ADDENDUM

PROJECT: Forestside Estates
Attmar & Palleschi Drive
Brampton, Ontario

ADDENDUM NO. E-1

PURPOSE: To suit architecture changes, Mech Addendum M-2 and clarification.

DRAWN	SP	CHECKED	MG	SCALE	1:100
DATE	MAY, 2019	PROJECT	18-017	DRAWING	E-2A
				OF	16

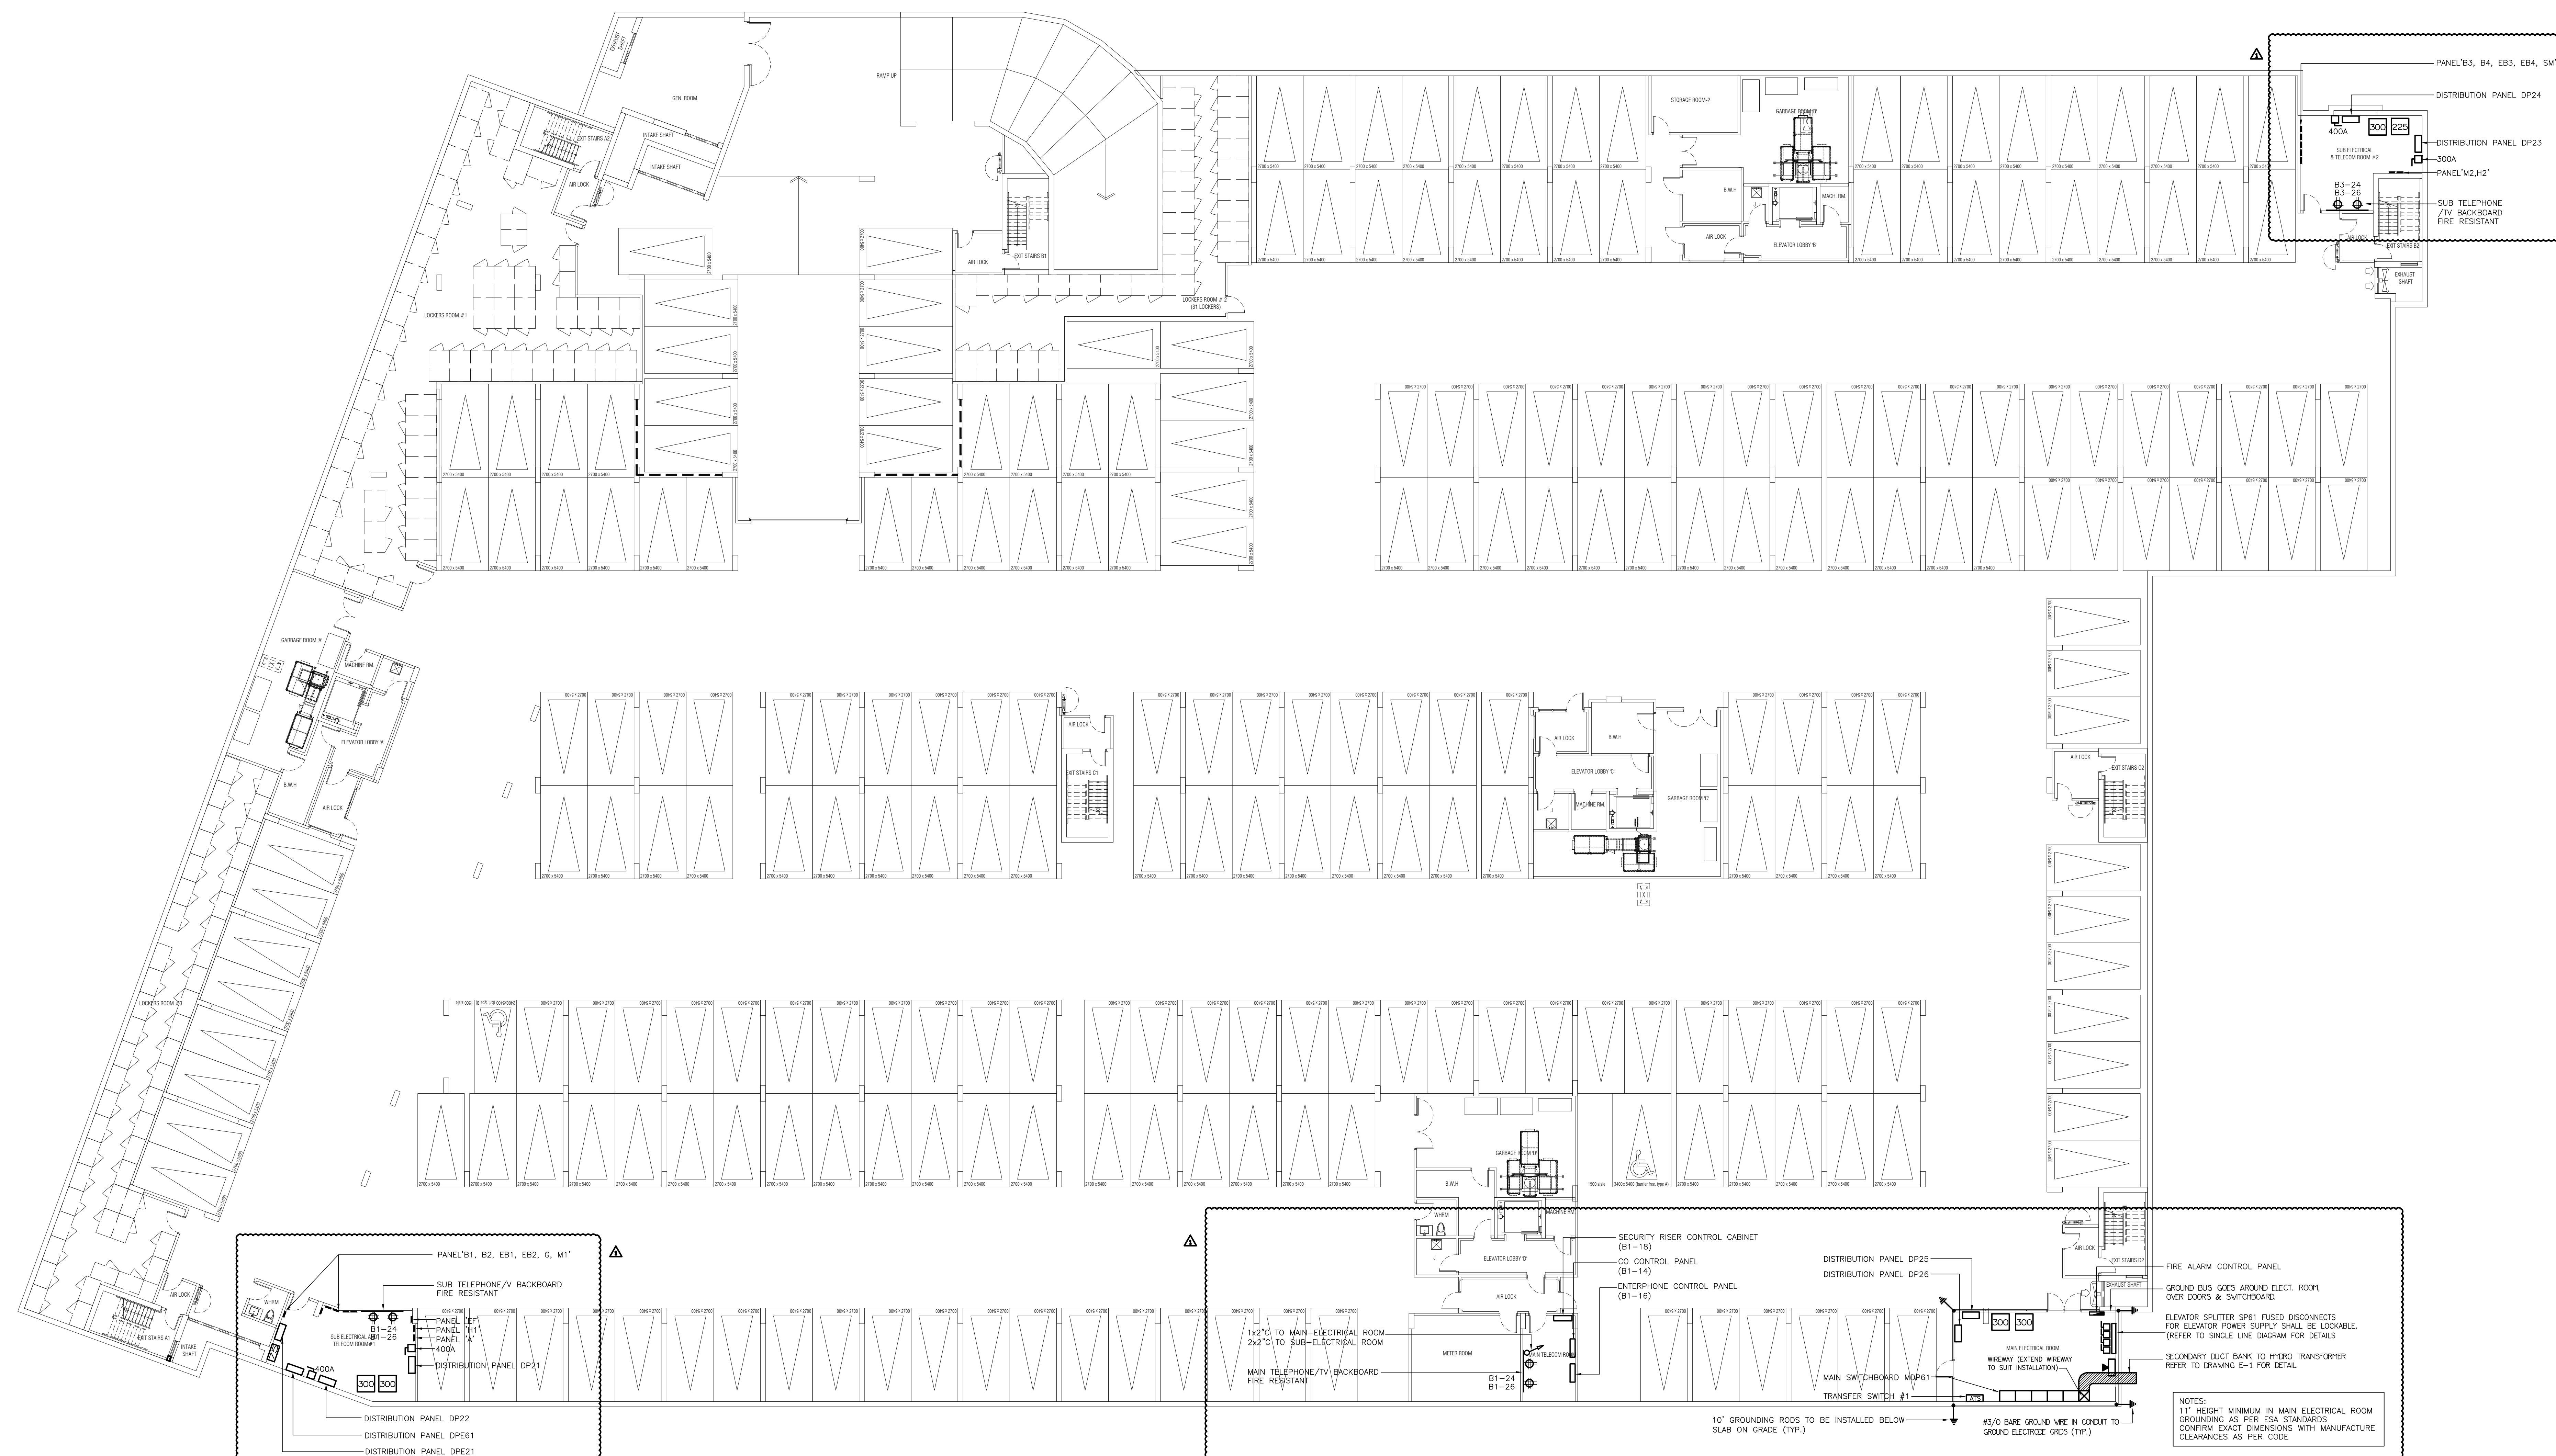
1.0 Reference Drawings E-2A (Parking Level Part A - Electrical) Issued
E-2B (Parking Level Part B - Electrical)
E-2C (Parking Level – Electrical Room Layout)

1.1 Revise: Electrical layout to suit latest arch drawings as shown.
